寄件者: Fongs Property
寄件日期: 2025年09月22日星期一 21:03
收件者: William Shu Tai WONG/PLAND
主旨: 回覆: [Planning Application No. A/NE-MUP/218] Proposed Temporary Warehouse (excluding Dangerous Goods Godown) and Associated Filling of Land for a Period of 3 Years in "AGR" Zone, Lot 30 S.B RP in D.D. 38, Sha Tau Kok, New Territories
附件: 回復TD.pdf; LAYOUT PLAN.pdf; Sightline Analysis.pdf; swept path analysis.pdf
類別: Internet Email

Re: [Planning Application No. A/NE-MUP/218] Proposed Temporary Warehouse (excluding Dangerous Goods Godown) and Associated Filling of Land for a Period of 3 Years in "AGR" Zone, Lot 30 S.B RP in D.D. 38, Sha Tau Kok, New Territories

Proposed Run-in/out and Sightline Analysis 建議出入口的視線分析

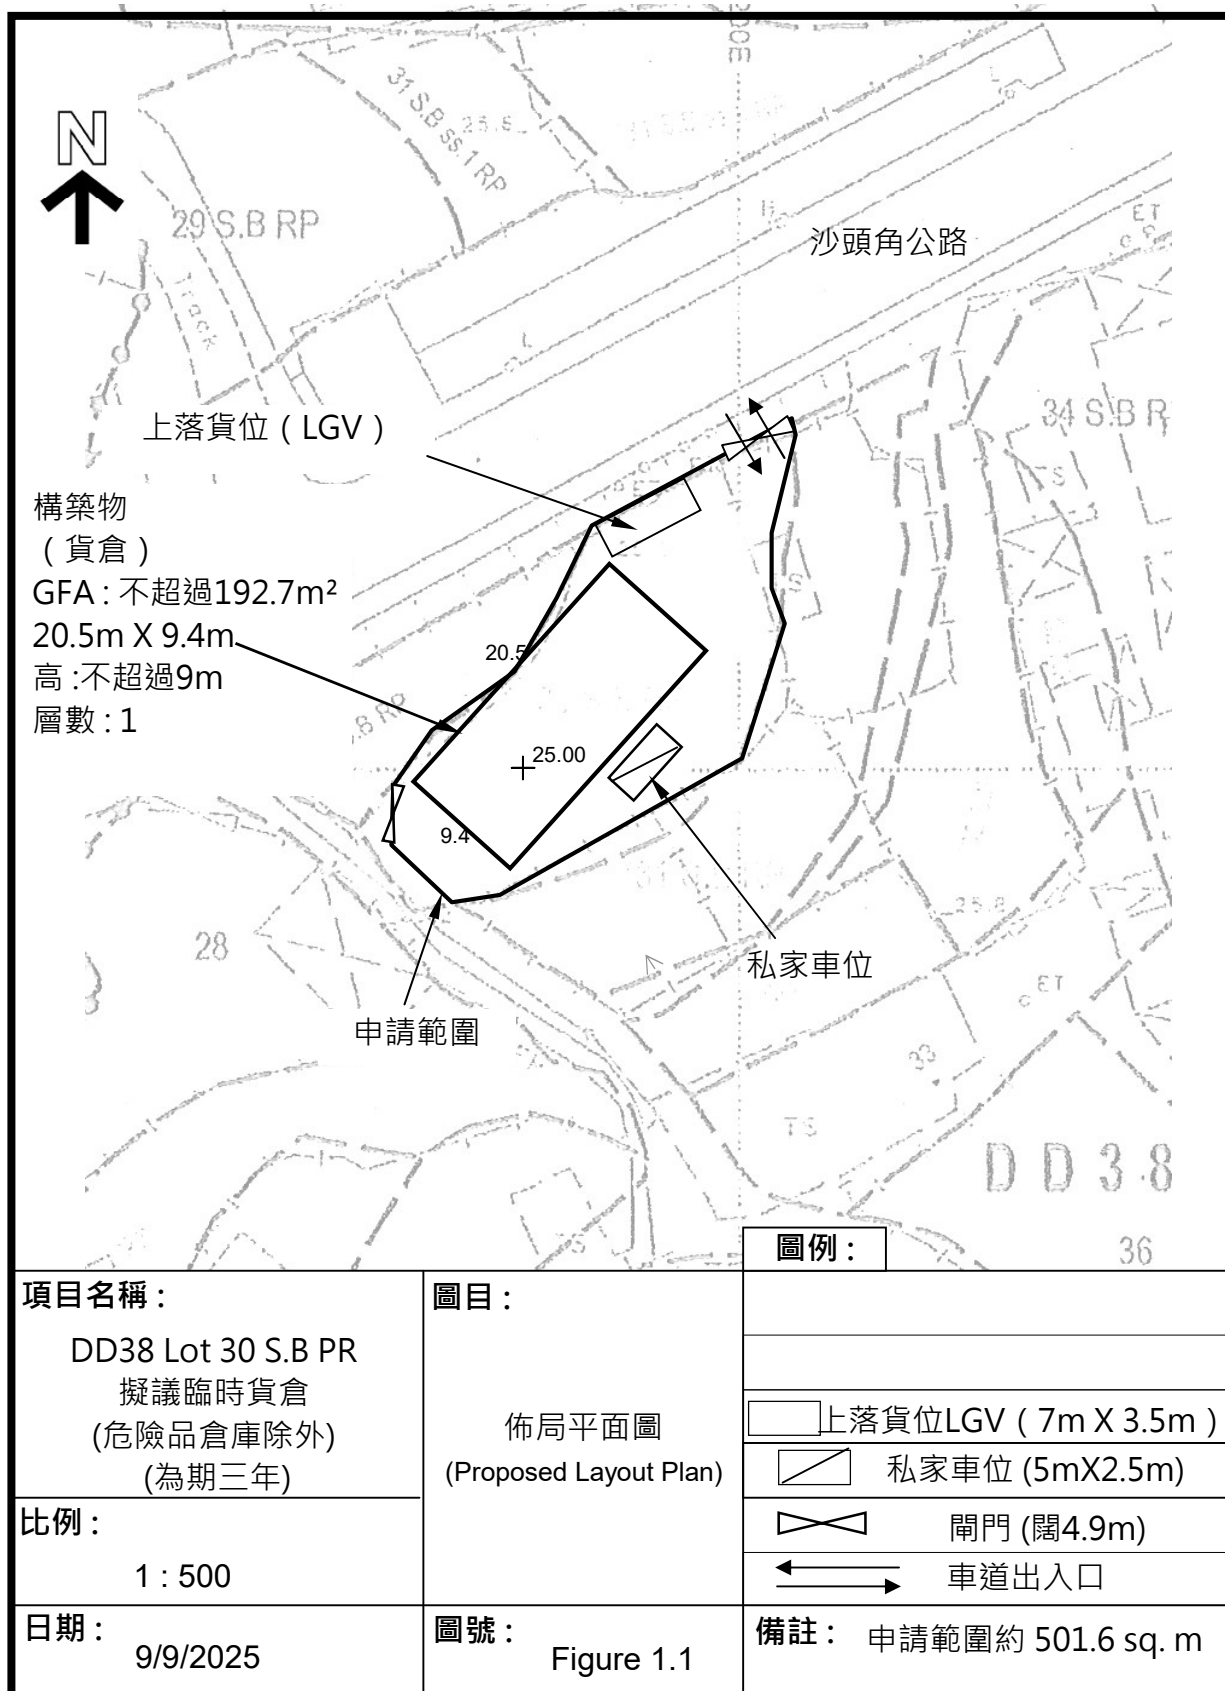
1. Our previous comment "The applicant should justify the adequacy of the proposed 4.6m width of the ingress and egress points for vehicular access" has not been addressed;

(1) 根據運輸署的意見申請人在本次規劃有以下的修正/改動，
(a) 把原先4.6米的出入閘門改為4.9米 (經實地量度是可行的)，
(b) 計劃使用的中型及重型貨車改為輕型貨車，
閘口改闊後足夠輕型貨車的進出，另外補充出入口視線分析圖 (Sightline Analysis)

項目名稱： DD38 Lot 30 S.B PR 擬議臨時貨倉 (危險品倉庫除外) (為期三年)	圖目： 掃描行車路線 (進入) SWEPT	 上落貨位LGV (7m X 3.5m)  私家車位 (5mX2.5m)  車道路線  閘門 (闊4.9米)
比例： 1 : 500		
日期： 9/9/2025	圖號： RS (in)	備註：

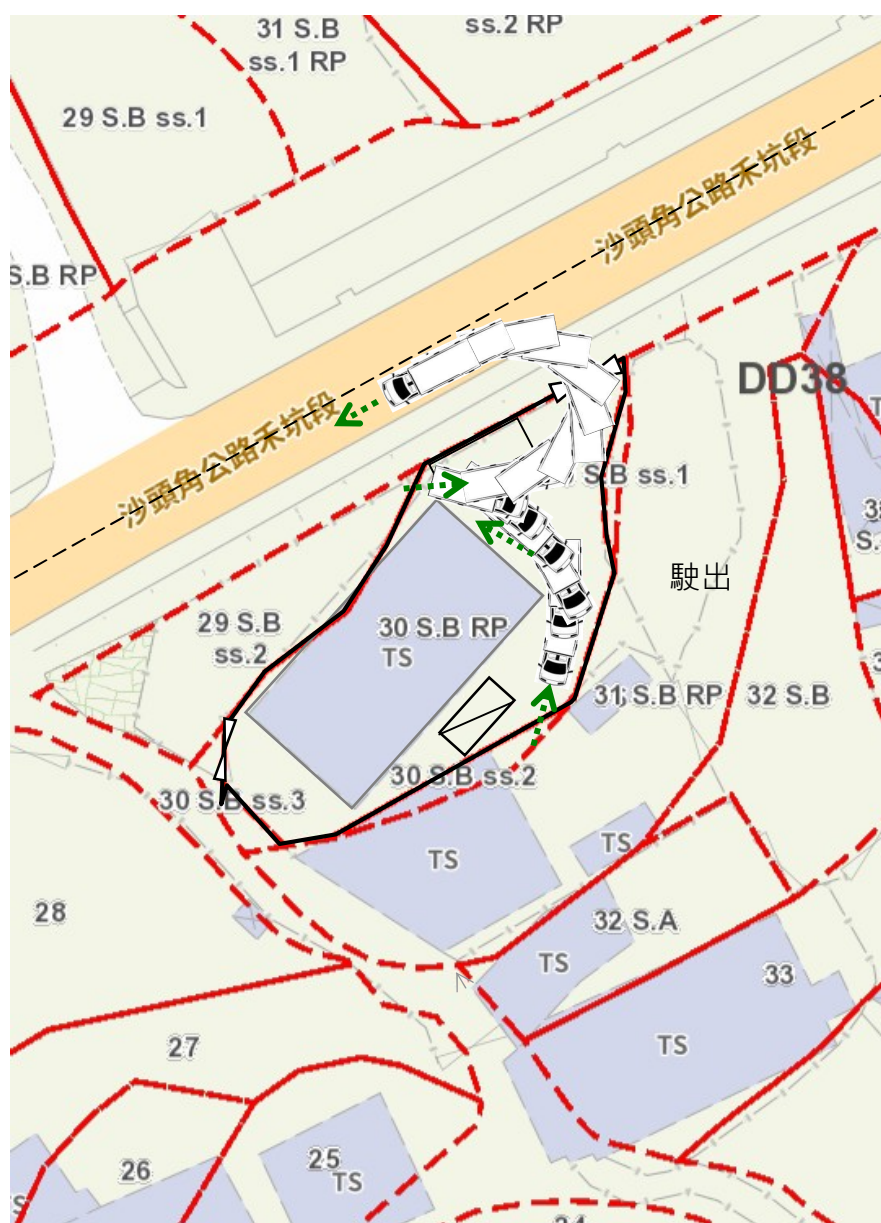
2. Our previous comment "The applicant shall demonstrate the satisfactory maneuvering of the vehicles entering and exiting the subject site without reverse movements onto / from Sha Tau Kok Road, maneuvering within the subject site and into / out of the parking and loading/unloading spaces, preferably using the swept path analysis" has not been address. The swept path for left-in movement entering the site is inadequate. Also, swept path analyses for M/HGVs should be provided for these cases including left-in, left-out, right-in and right-out, joining / leaving Sha Tau Kok Road to / from the development without the need to encroach onto the opposite lane.

(2) 提供計劃修訂後有關輕型貨車的swept path analysis
